**METROPOLITAN GOVERNMENT OF NASHVILLE AND DAVIDSON COUNTY**

**STAFF RECOMMENDATION**  
**2511 Natchez Trace**  
**January 21, 2015**

**Application:** New construction-infill and outbuilding  
**District:** Hillsboro-West End Neighborhood Conservation Zoning Overlay  
**Council District:** 18  
**Map and Parcel Number:** 104150048600  
**Applicant:** Randy Robinson  
**Project Lead:** Paul Hoffman, paul.hoffman@nashville.gov

**Description of Project:** The applicant proposes new construction of a single-family residence and attached garage on one of three newly subdivided lots in an area that was originally two lots.

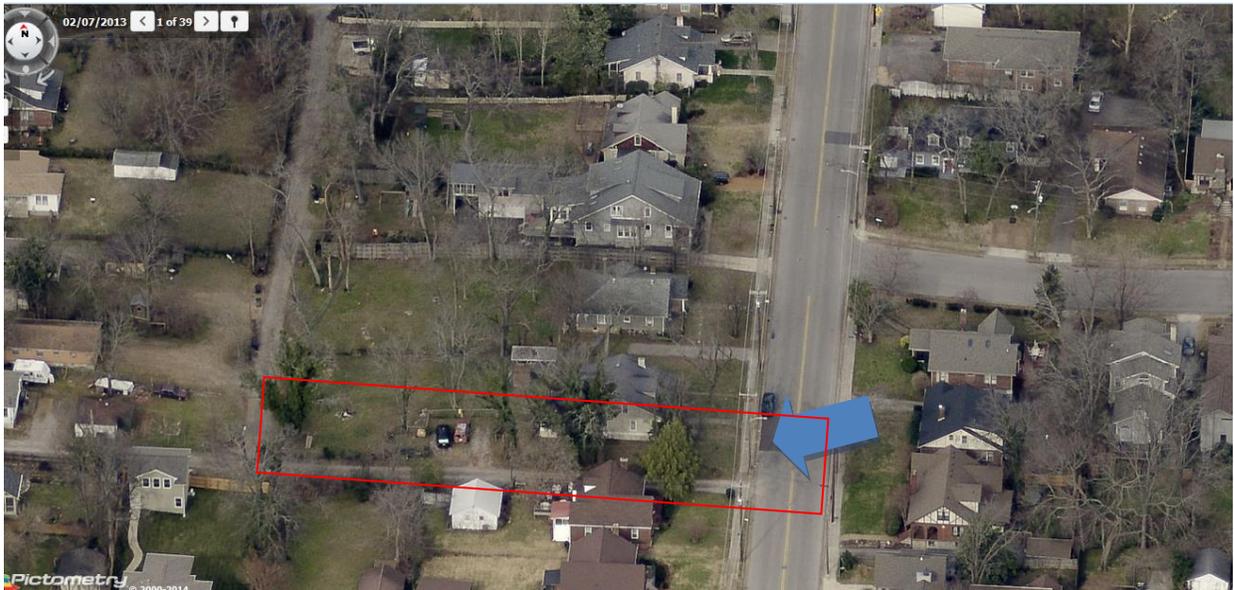
**Height & Scale:** The new building will be two stories with a ridge height of approximately thirty-two feet (32') from grade, as seen from the front. Contributing homes in Hillsboro-West End range from eighteen to twenty-nine feet (18'-29') in height from grade. The neighboring contributing home at 2507 Natchez Trace (see Figure 1) is twenty-seven feet (27') from grade. Staff finds that the proposed height is too tall for the context on Natchez Trace, and requests the height of this infill be reduced to that of the other two projects, no more than twenty-seven feet (27') from grade at the front.

1. The ridge height be brought down to be no more than twenty-seven feet (27') from grade at the front of the house;
2. Two window openings added to the right elevation, to break up the long expanses on the second story;
3. The finished floor height shall be consistent with the finished floor heights of the adjacent historic houses, to be verified by MHZC staff in the field;
4. Staff approve the final details, dimensions and materials of the siding material, roofing color, porch columns, windows, doors and garage doors prior to their purchase and installation.

**Figure 3:** Staff recommends windows be added to the areas shown on the left.

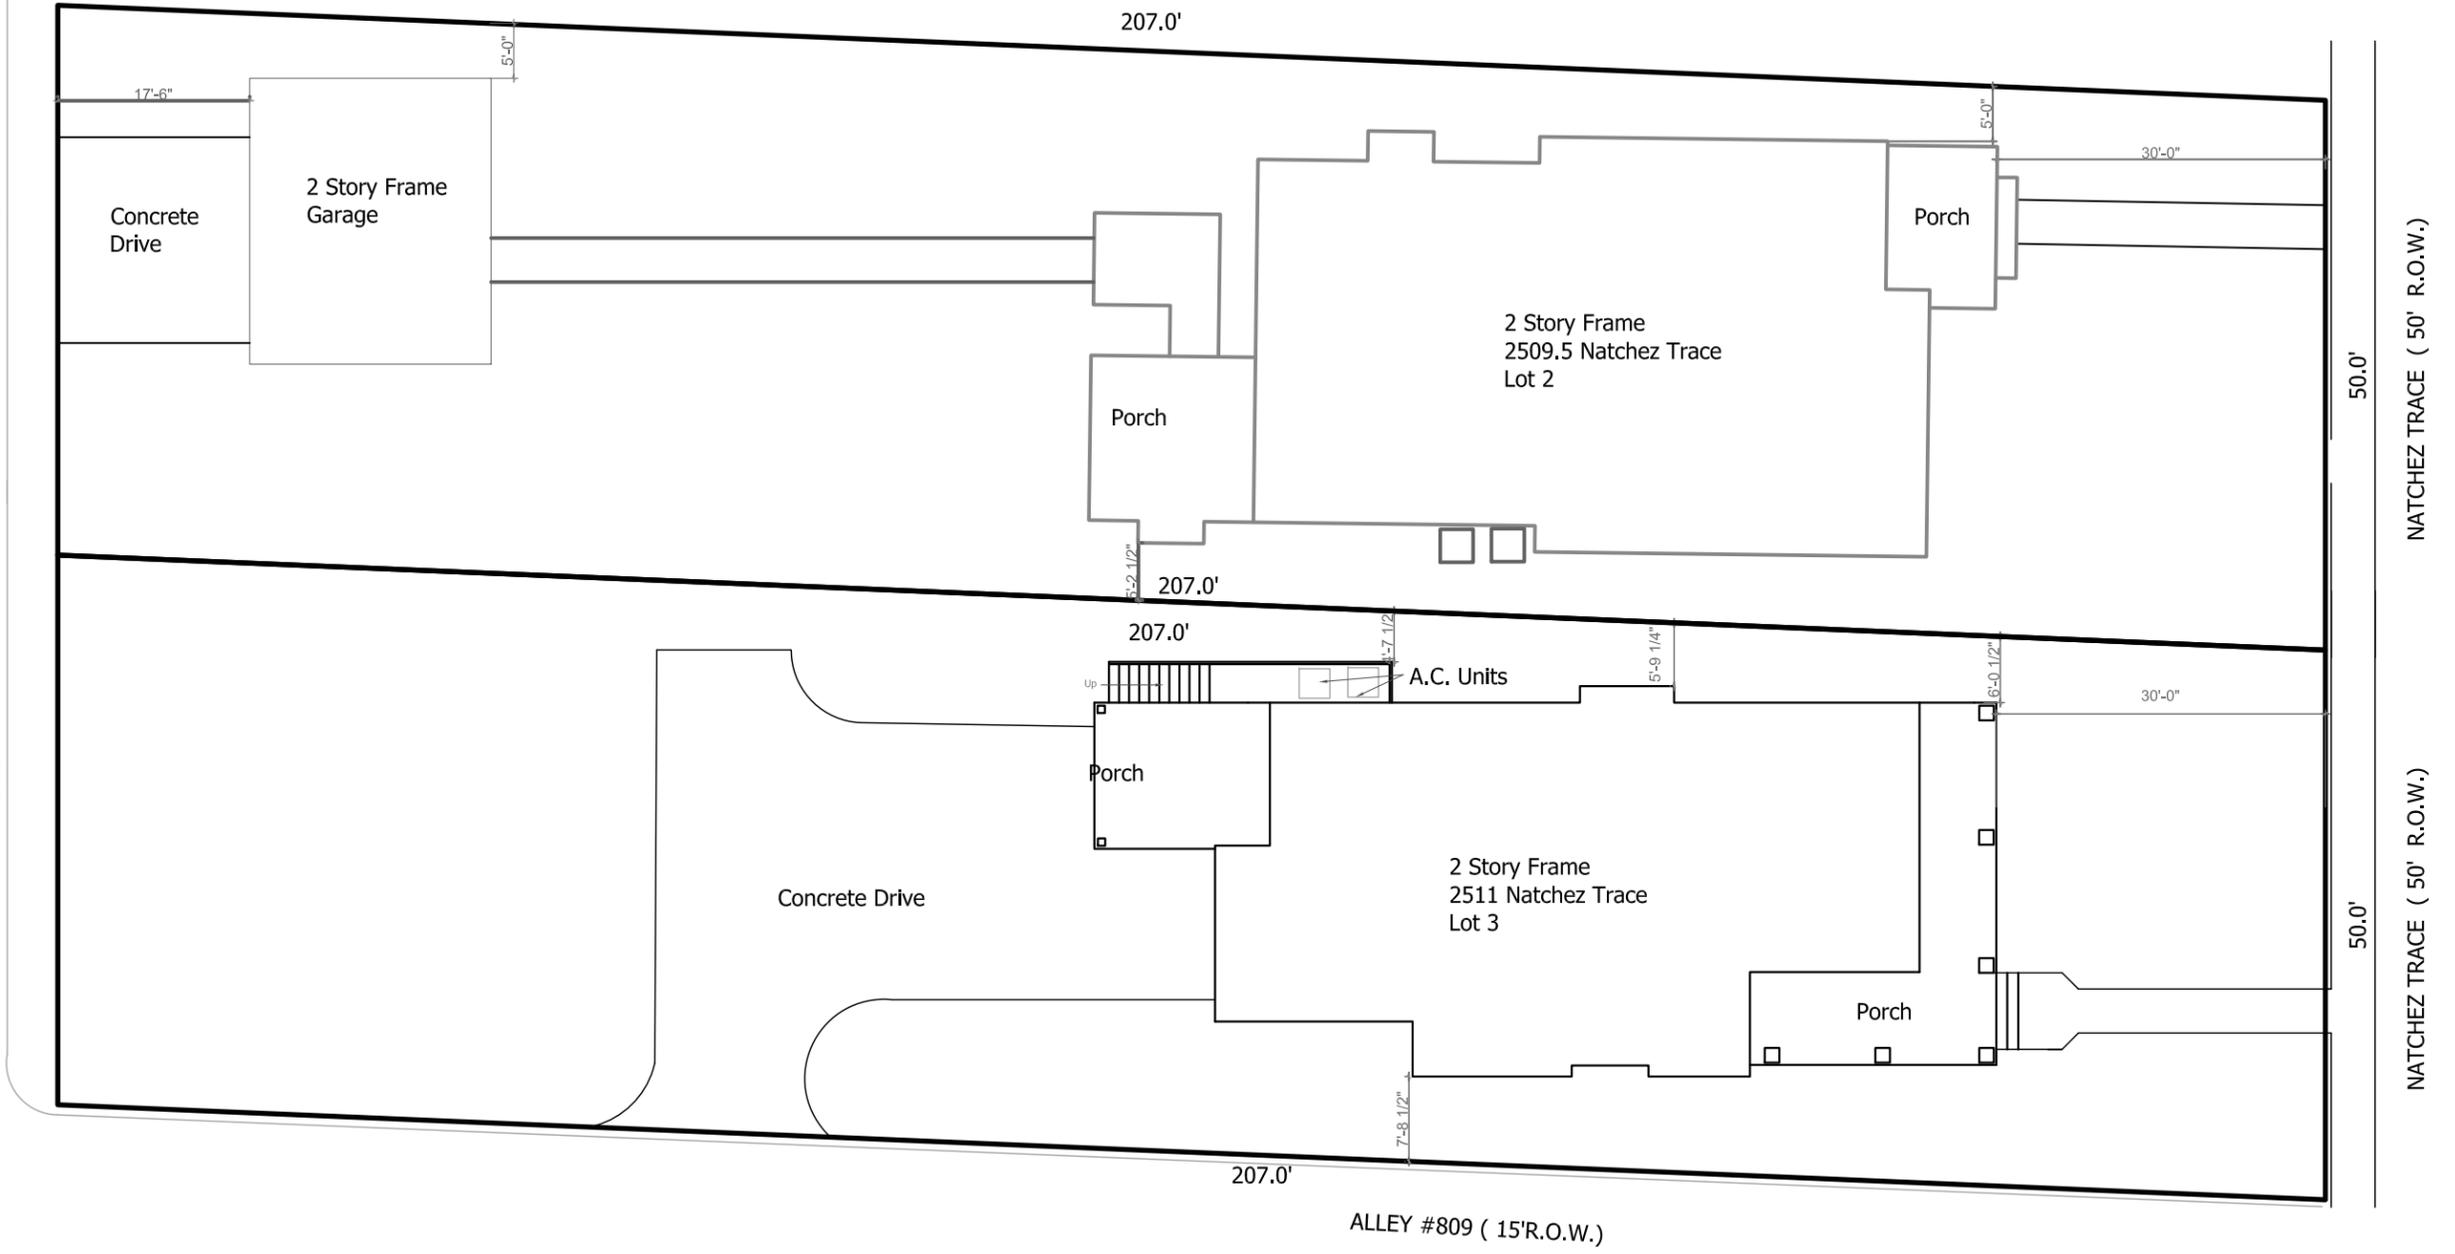
**Proportion and Rhythm of Openings:** The windows are generally twice as tall as they are wide, thereby meeting the historic proportions of openings. There are two long expanses on the right elevation of wall space without a window opening. These areas of approximately twenty feet (20') and twenty-two feet (22') exceed the recommended area without an opening. Staff requests a window opening be added to both of these areas, to break up the wall space. With this condition, Staff finds the project's proportion and rhythm of openings to meet Section II.B.1.g.

1. The ridge height be reduced to no greater than twenty-seven feet (27') from grade at the front of the house;
2. Two window openings be added to the right elevation, to break up the long expanses on the second story;
3. The finished floor height shall be consistent with the finished floor heights of the adjacent historic houses, to be verified by MHZC staff in the field;
4. Staff approve the final details, dimensions and materials of the siding material, roofing color, windows, doors and garage doors prior to purchase and installation.
